PARTS & SERVICE NEWS

REF NO.	AT00244
DATE	Nov. 27, 2000
(C)	Page 1 of 11

SUBJECT: INTRODUCTION OF LOW OPERATOR COMPARTMENT NOISE SPEC. PARTS FOR HD325/405-6

PURPOSE: To introduce newly prepared "low compartment noise spec. parts" for installation on HD325-6 and HD405-6 dump trucks

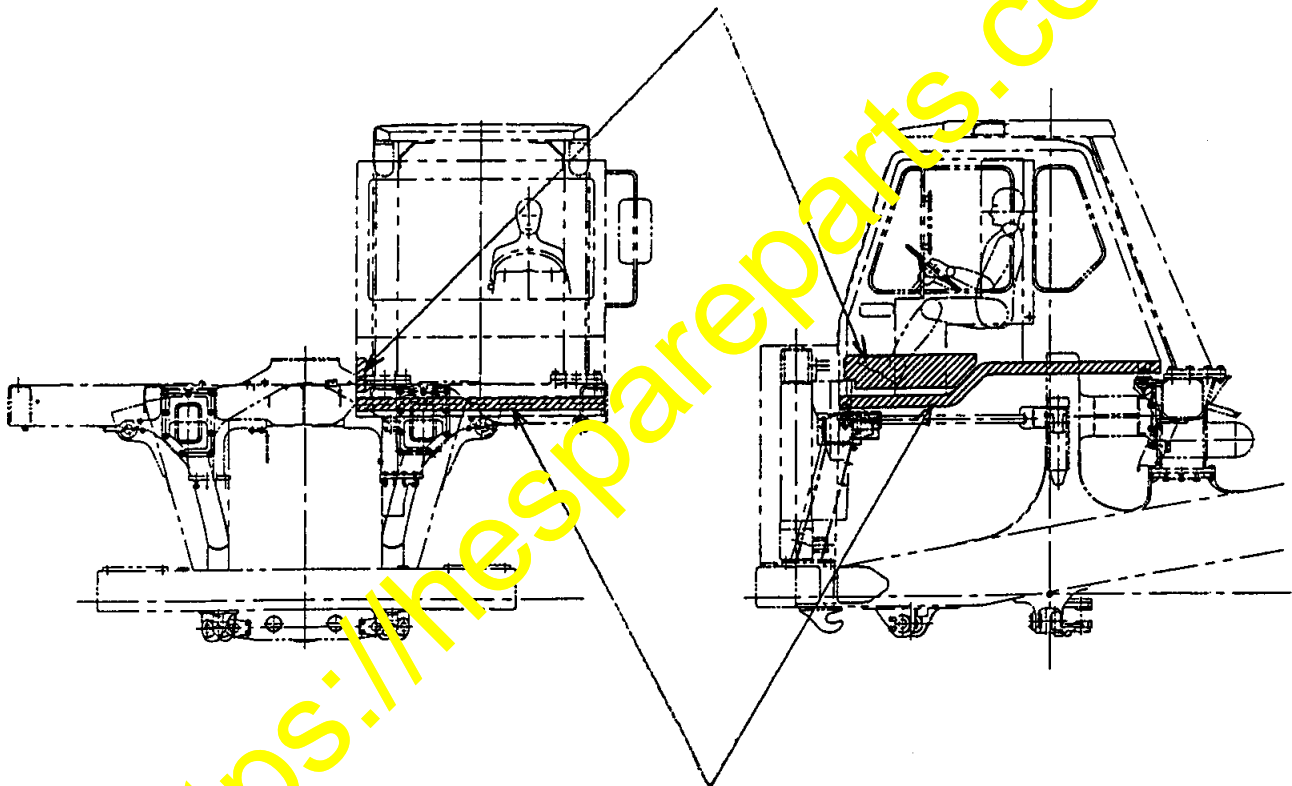
(1) Making the cab floor to a duplex structure

Making the cab floor to a duplex structure, insert dampers and sound absorbing material sheets in between.

(2) Supplementing the dampers and sound absorbing materials to the lower section of the RH door of the operator's cab

Since this section is hollow inside, supplement the dampers and sound absorbing materials in there.

(1) Checking the sealing capacity of the LH operator's cab door

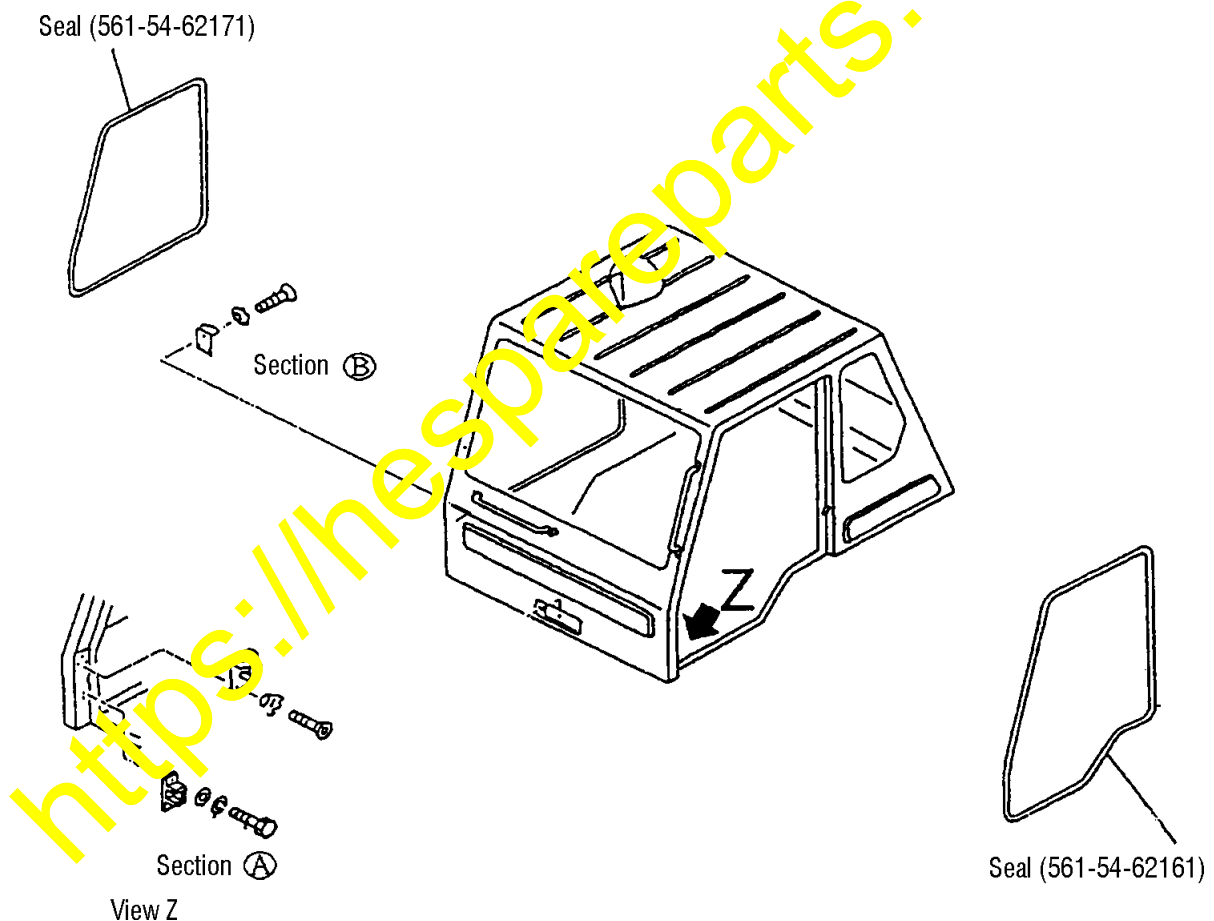
Check and make sure that the door seal (561-54-62161) is being flattened evenly when the door is closed, thus providing secure sealing effect. If the seal is not being flattened evenly, adjust the section ①.

Also, when the seal is found defective, replace it with a new seal.

Check and make sure that the door seal (561-54-62171) is being flattened evenly when the door is closed, thus providing secure sealing effect. If the seal is not being flattened evenly, adjust the section ②.

Also, when the seal is found defective, replace it with a new seal.

Fig. 3

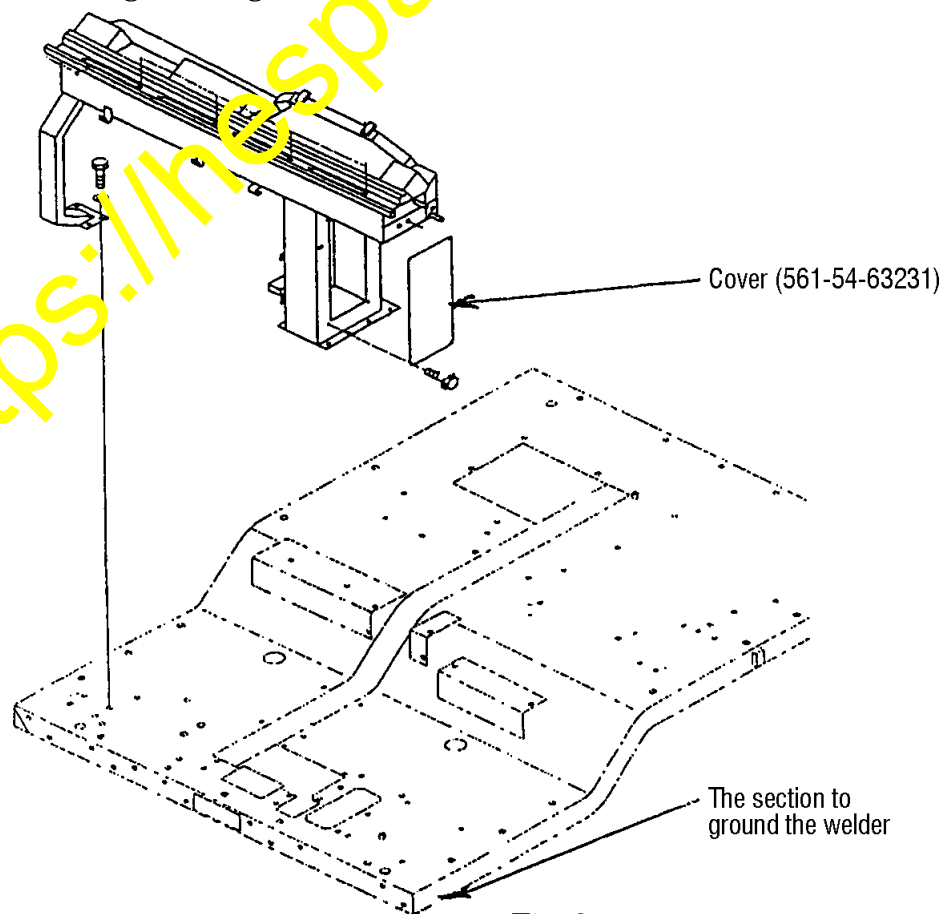
As for the sheets ㉕ and ㉖, remove the steering column cover (561-54-63231) located inside the operator's cab to apply them onto the upper surface of the floor. (Refer to Fig. 3.)

Fig. 4

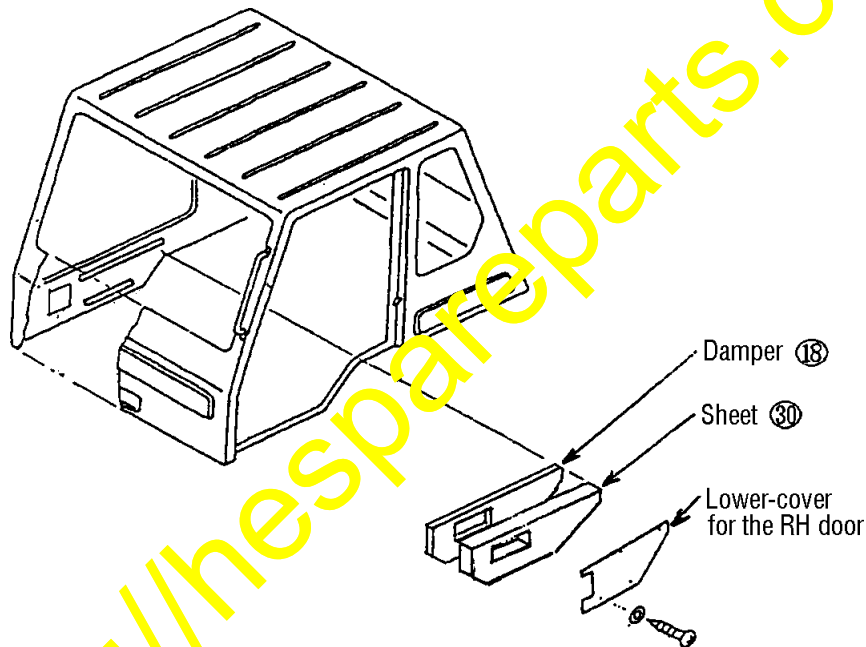
Apply the damper ⑱ (569-89-65320) to the surface at the section from where the lower-cover (561-54-62382) for the RH door has been removed. Since adhesive is being pre-applied onto one side of the damper, remove the protection sheet before applying the damper. At this time, depress the damper onto the operator's cab panel using a hammer or the sort.

Apply the sheet ⑳ (569-89-65530) onto the surface of the damper ⑱. Since adhesive is being pre-applied onto one side of this sheet, remove the protection sheet before applying the sheet onto the damper surface.

If it is difficult to apply the aforementioned damper ⑱ and sheet ⑳ in whole being hindered by existence of the air conditioner hoses or other structures, they may be split to appropriate shapes.

Fig. 5 (Reworking drawing for the operator's cab floor: The above drawing is a bottom view, when looked up from underneath the operator's cab floor.)

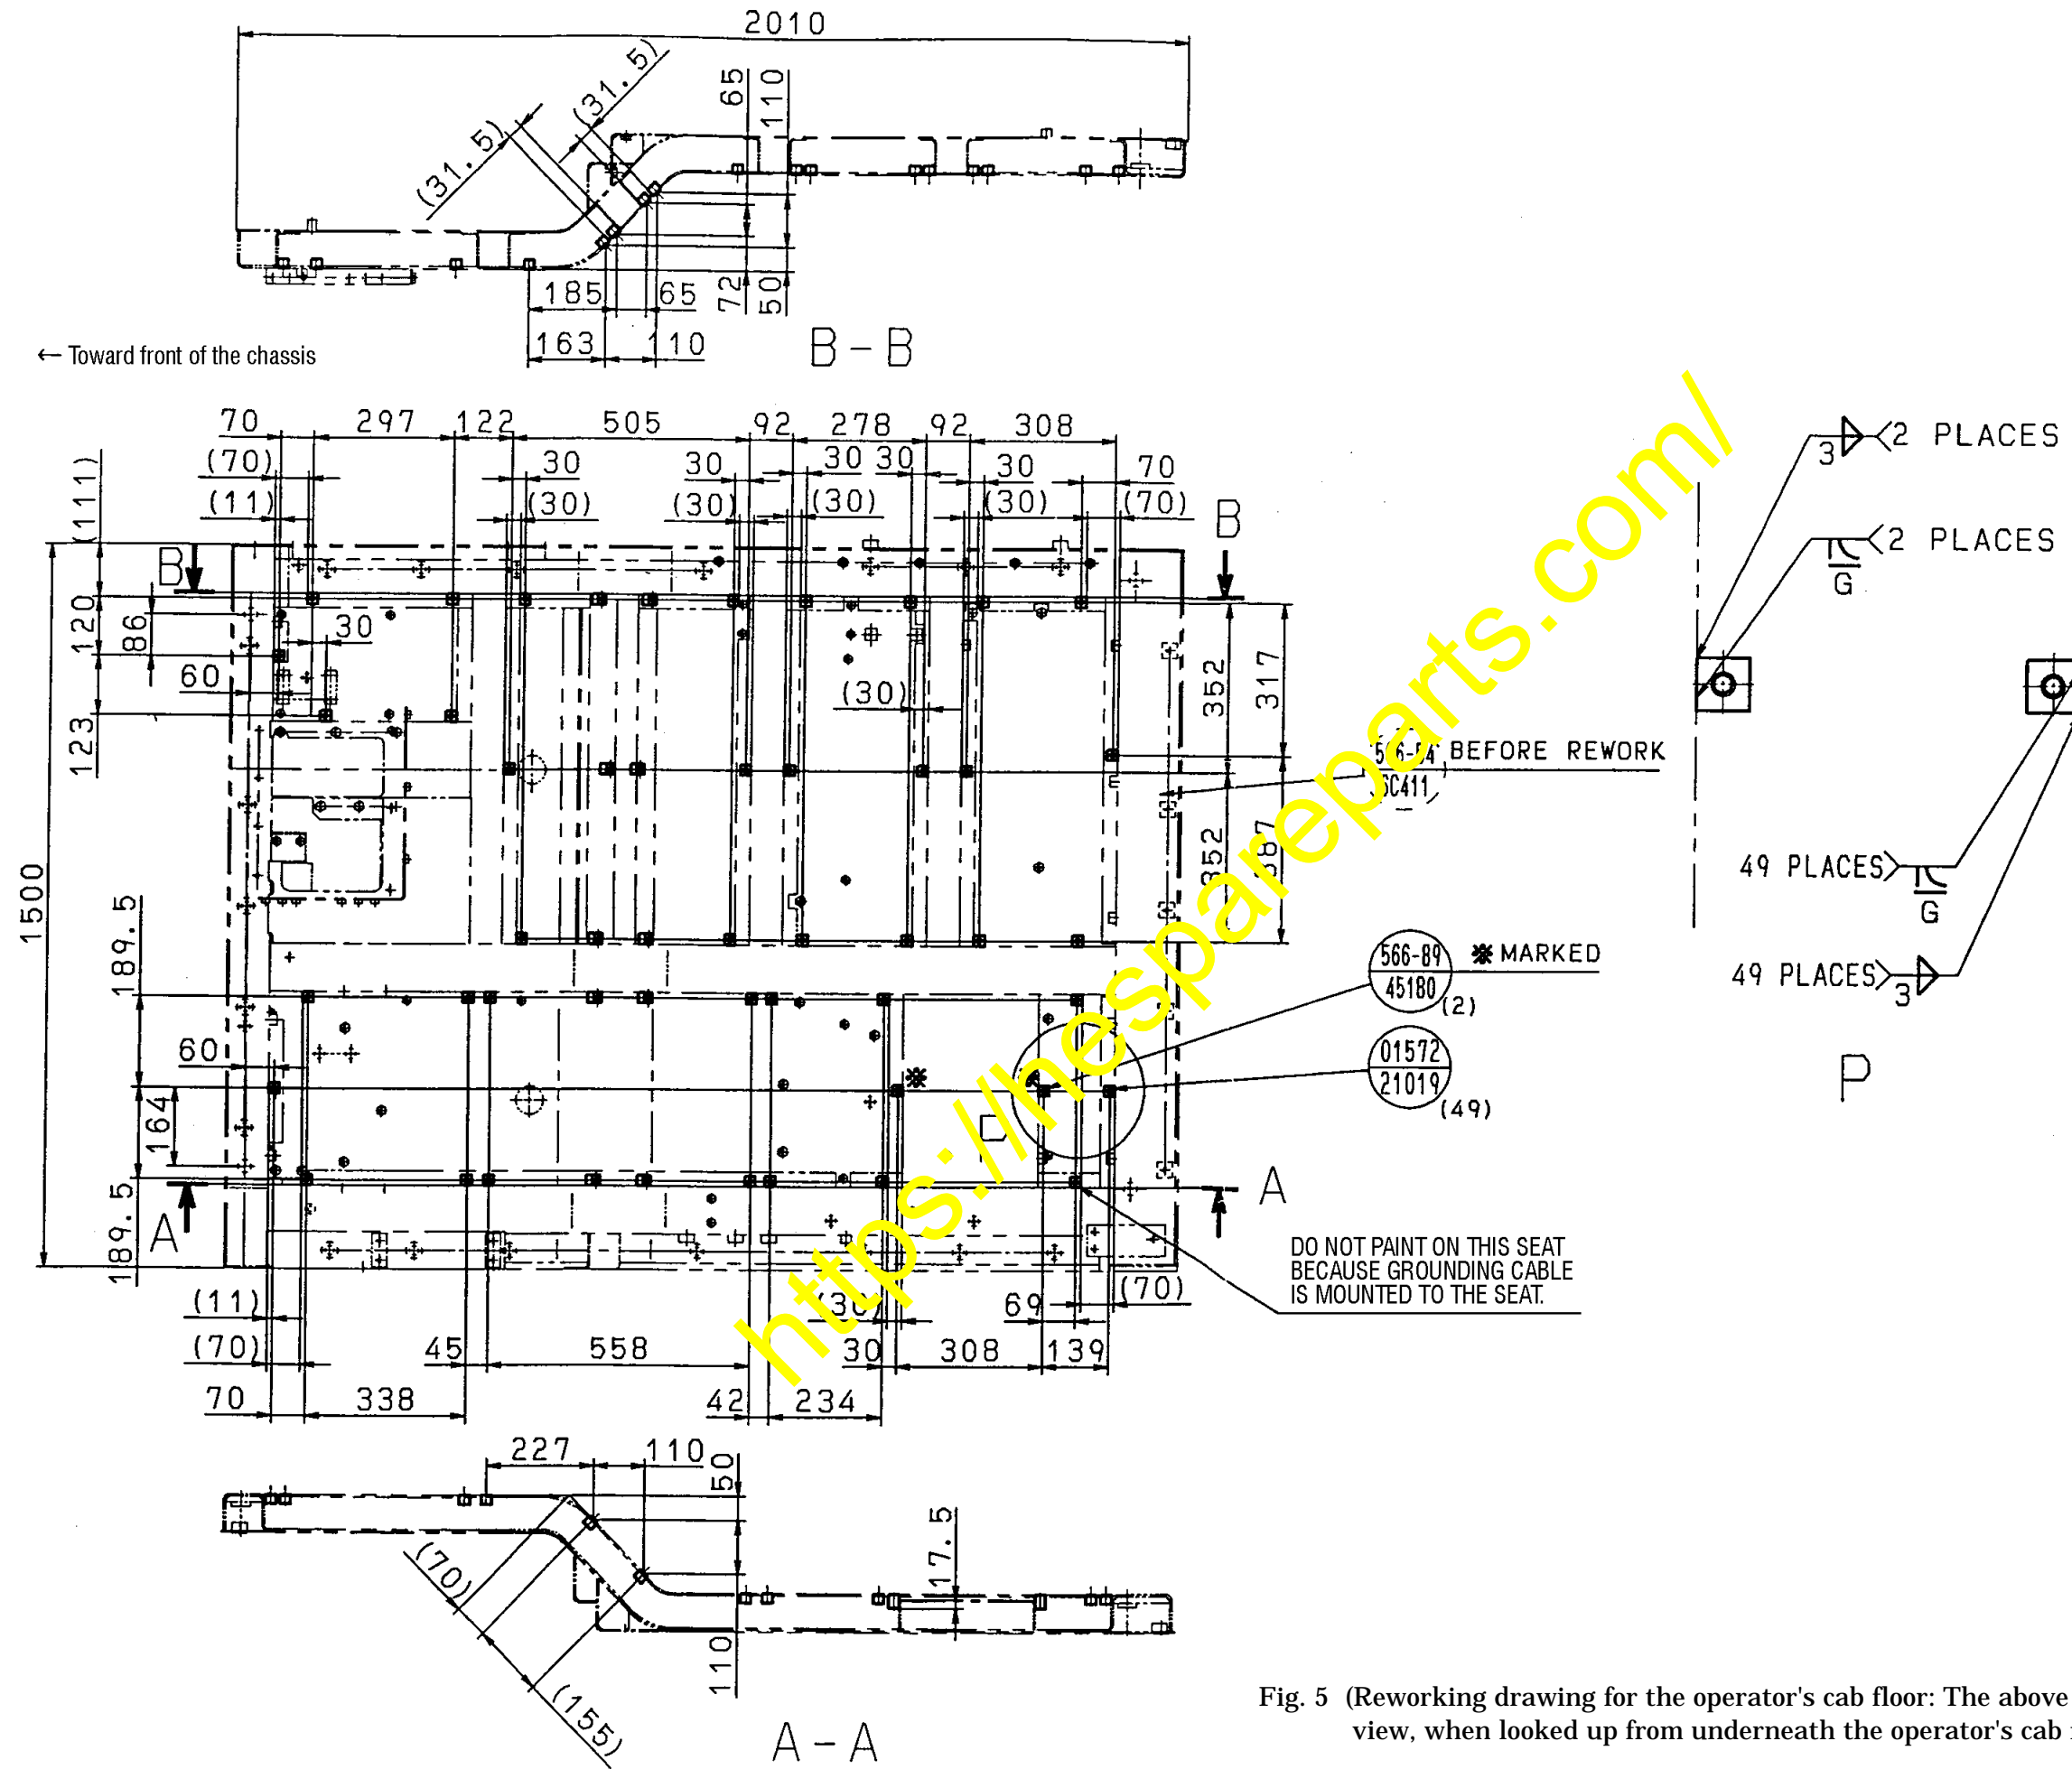
5-2. Reworking with the operator's cab floor (Refer to Fig. 5.)

Weld the seat ⑳ (01572-21019) and the seat ㉑ (566-89-45180) onto the bottom surface of the operator's cab floor.

※ **Connect the grounding lead of the welder to the cab GND section located on the bottom surface, in the front section toward left, of the cab floor.**

Fig. 6 (Drawing for installation of the dampers: The above drawing is a bottom view, when looked up from underneath.)

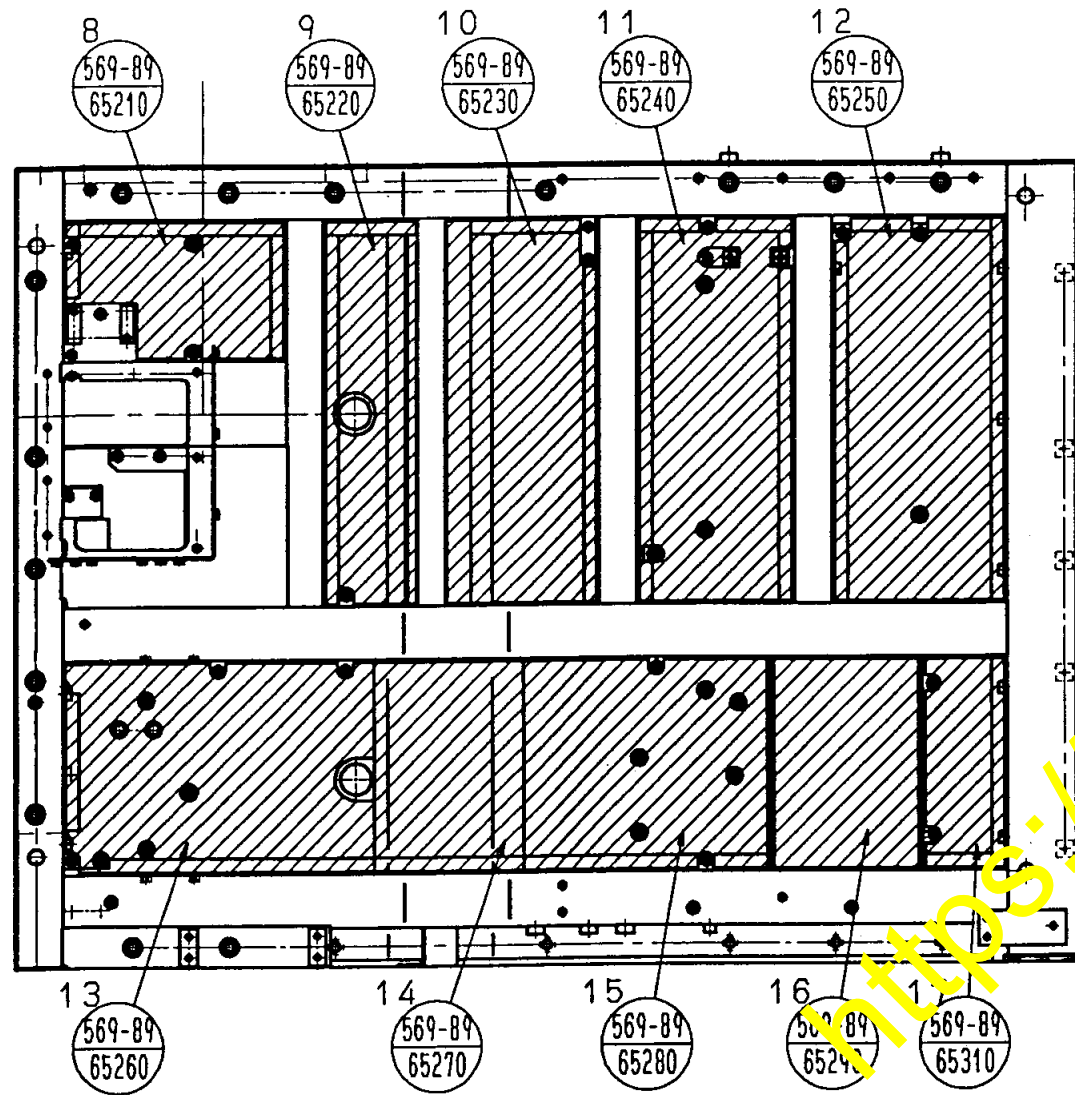
Apply the dampers ⑧ thru ⑰ onto the bottom surface of the operator's cab floor. Since adhesive is being pre-applied onto one side of the dampers, remove the protection sheet before applying the dampers. At this time, depress the dampers onto the bottom surface of the operator's cab floor using a hammer or the seat.

Fig. 7 (Drawing for installation of the sheets: The above drawing is a bottom view, when looked up from underneath.)

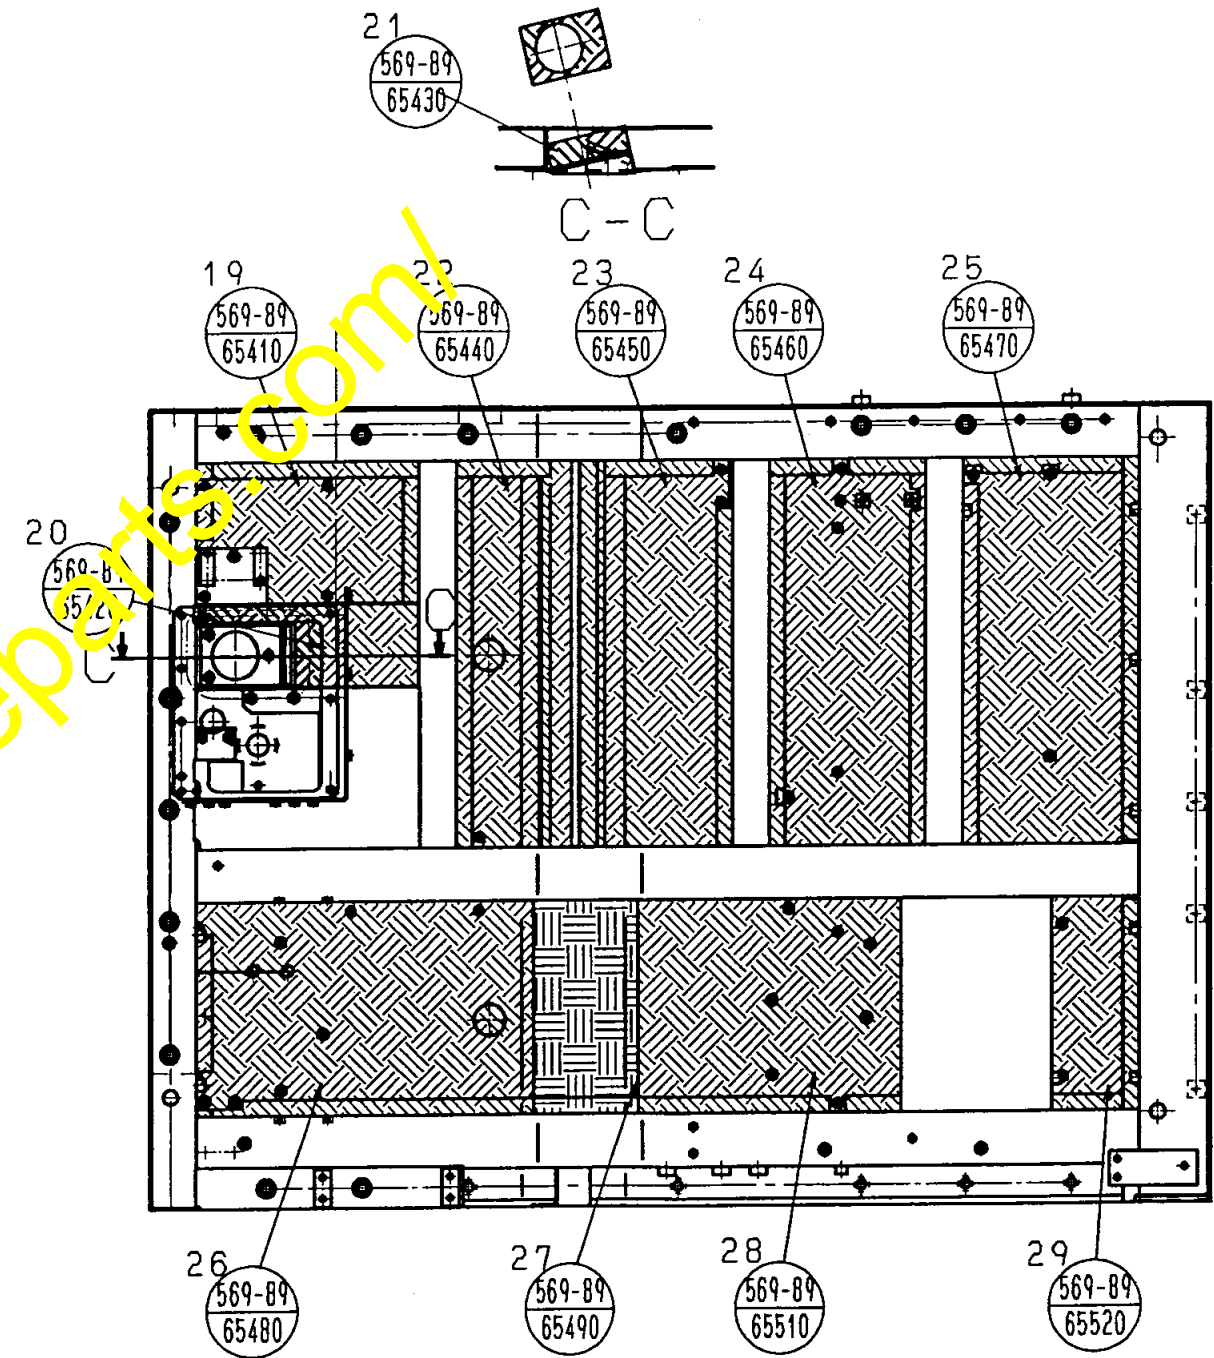
Apply the sheets ⑱ and ㉒ thru ㉔ onto the surface of the dampers which have been applied onto the bottom surface of the operator's cab floor according to the procedure in the above Paragraph 1).

Since adhesive is being pre-applied onto one side of these sheets, remove the protection sheet before applying them onto the damper surfaces.
